RE: Point Beach Nuclear Plant, Units 1 and 2  
Docket No. 030-39380

Revision to Radioactive Materials License 48-35752-01, Amendment 1

Point Beach Units 1 and 2  
Revision to Radioactive Materials License 48-35752-01, Amendment 1

**TURKEY POINT UNIT 4, CYCLE 35  
REFERENCE CORE LOADING PATTERN**

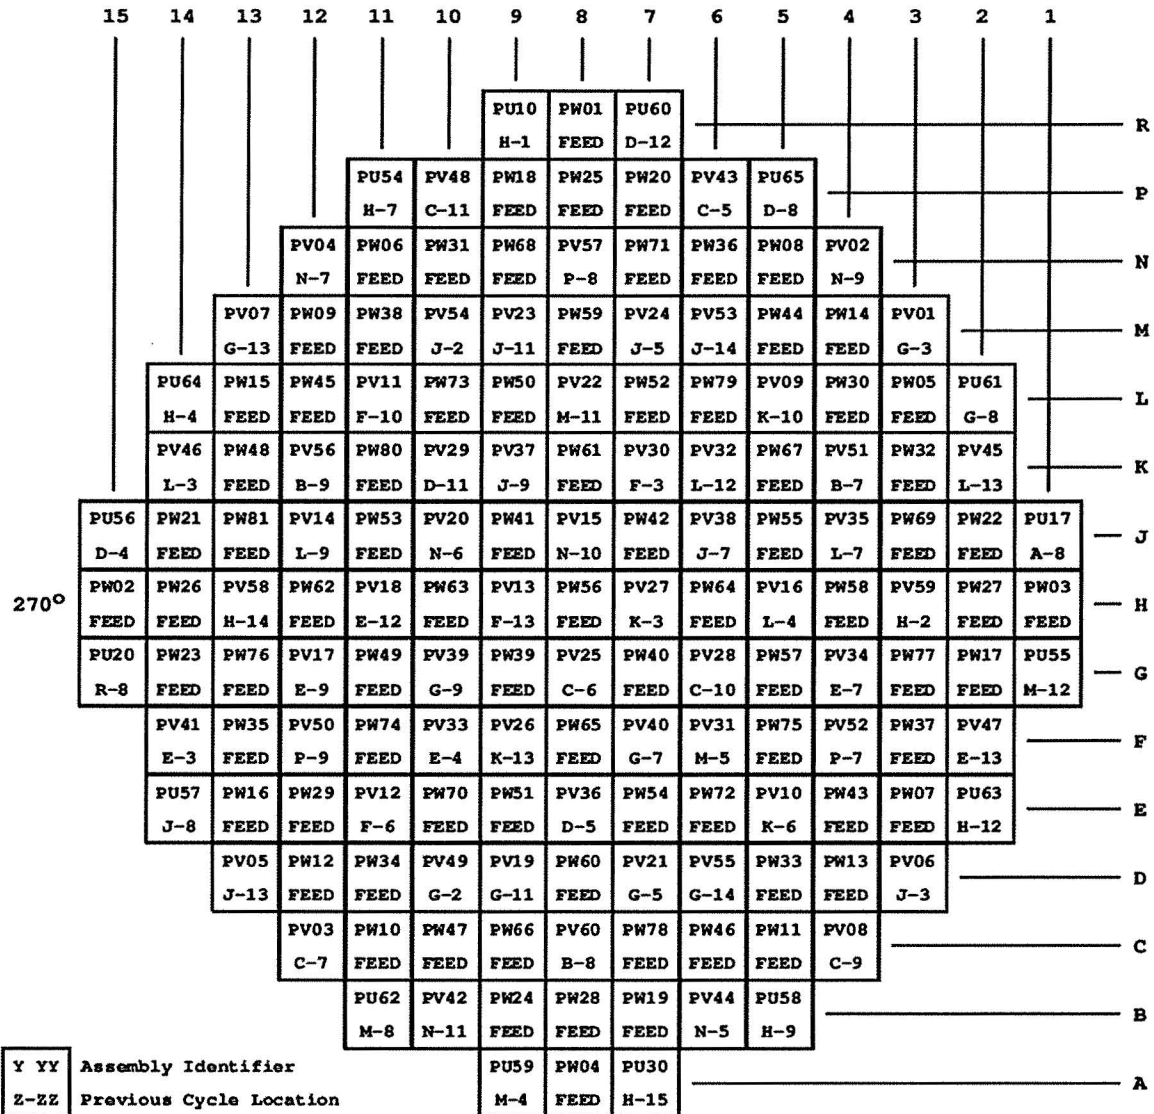
The method of [ ] needs to be changed [ ]. The proposed changes are associated with [ ]. The changes will not [ ] described in the license.

Proposed addition of sections 6.E, 7.E, 8.E, and 9.E are to [ ].
